# Application for "Other Business"

## Cobb County, Georgia

State specifically the need or reason(s) for Other Business: Amend approved  
site plan.

Re: Application of Steak Properties, LLC to Rezone a 1.07 Acre Tract  
from R-20 to NRC (No. Z-8)

## LANDSCAPE DEVELOPMENT PLAN - ADDITIONAL PARKING AREA CHEROKEE CATTLE CO.

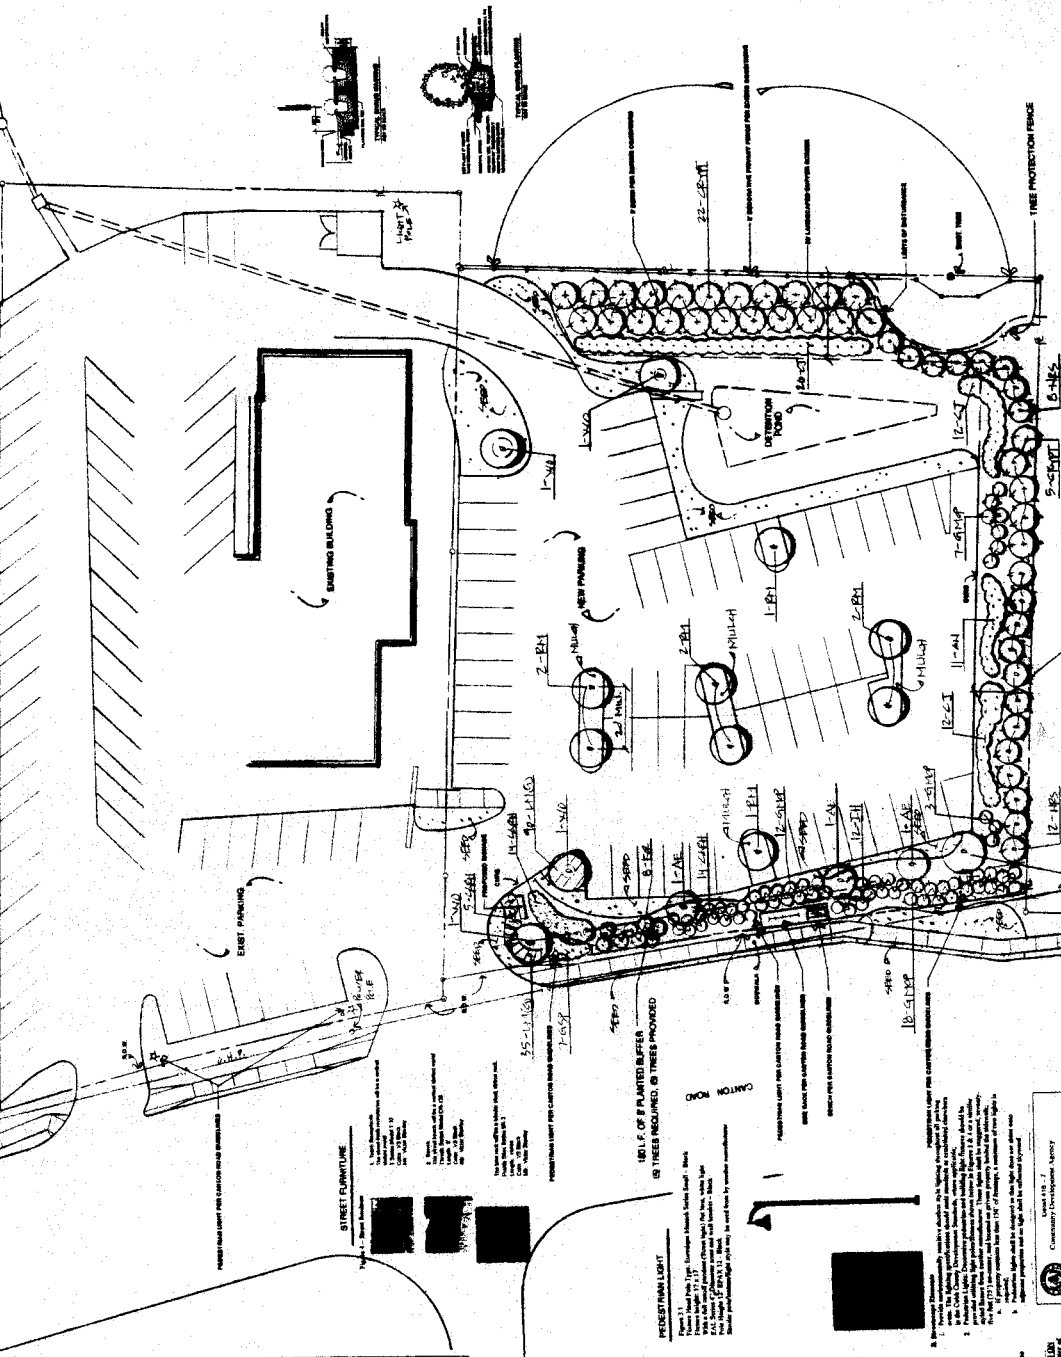
- No Stormwater controls shown \_\_\_\_\_
- Copy of survey is not current – Additional comments may be forthcoming when current site conditions are exposed.
- No site improvements showing on exhibit.

1. The proposed site plan for the parking lot expansion indicates that the existing detention pond on the current Cherokee Cattle Company site will be modified to accommodate the additional runoff. There does not appear to be sufficient area available in the current pond to accommodate the sufficient expansion needed and additional area will likely be required to provide the adequate storage volume needed. This must be addressed at Plan Review.

2. A small portion of the site drains to the southeast toward Chesterfield Drive. Runoff from this area drains through the adjacent residential neighborhood. The stormwater conveyance system in this older development has limited capacity. Any future development on the subject parcel that discharges to Chesterfield Drive will be required to control design storm discharges not to exceed the allowable discharge of the next lower, more frequent storm event (ie. 5-year storm event released at 2-year rate; 10-year event at 5-year rate; etc. to 100-year event at 50-year rate).
